BOARD OF ZONING APPEALS APPLICATION

at the following address 3660 Beulah Park Dr. Grove City, OH 43123 Parcel # 040-016189-00

NOTICE OF CORRECTIONS REQUIRED

Reference: Corrections Required for Permit Application #PR20230002804

FIRST FLOOR PLAN
SCALE: 1/4" = 1'-0"

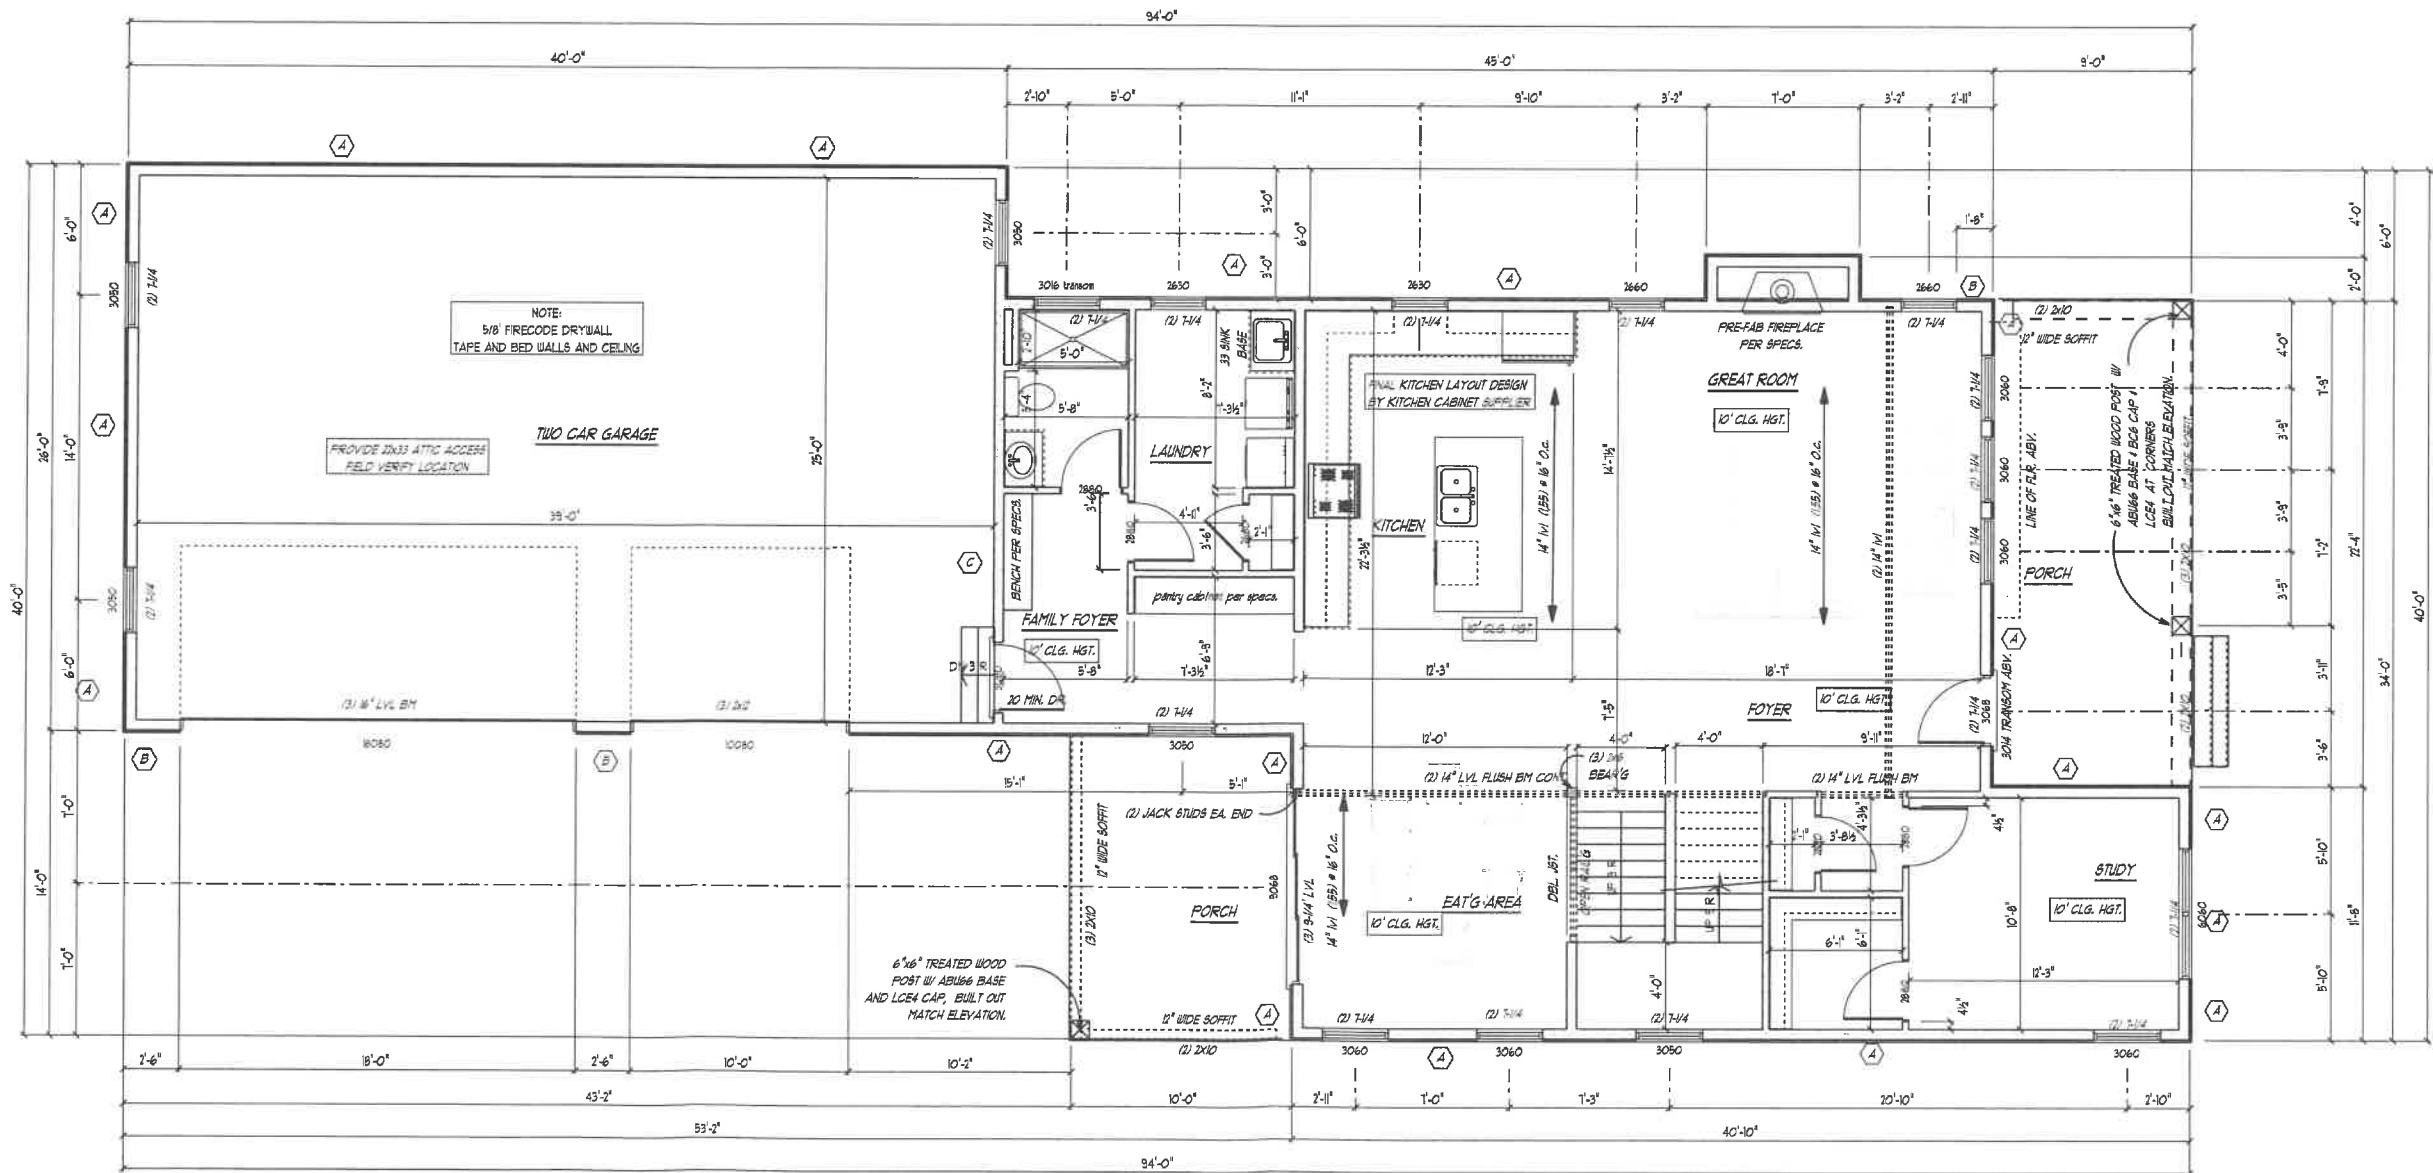
1. Architectural review approval letter is required for area C lots.
2. EPA permit for erosion control required for area C lots.
3. Garage sqft exceeds max 900 per city code 1135.10
https://codelibrary.amlegal.com/codes/grovecity/latest/gcity_oh/0-0-0-96884
A variance from the BZA will be needed for approval.

Variance to Section 1135.10^(a) to exceed the maximum size of an attached garage of 900 sf, by 140 sf, for a total of 1,040 sf. This is for the construction of a single family residence with 3-car garage with storage area. The proposed garage will measure 40' x 26'.
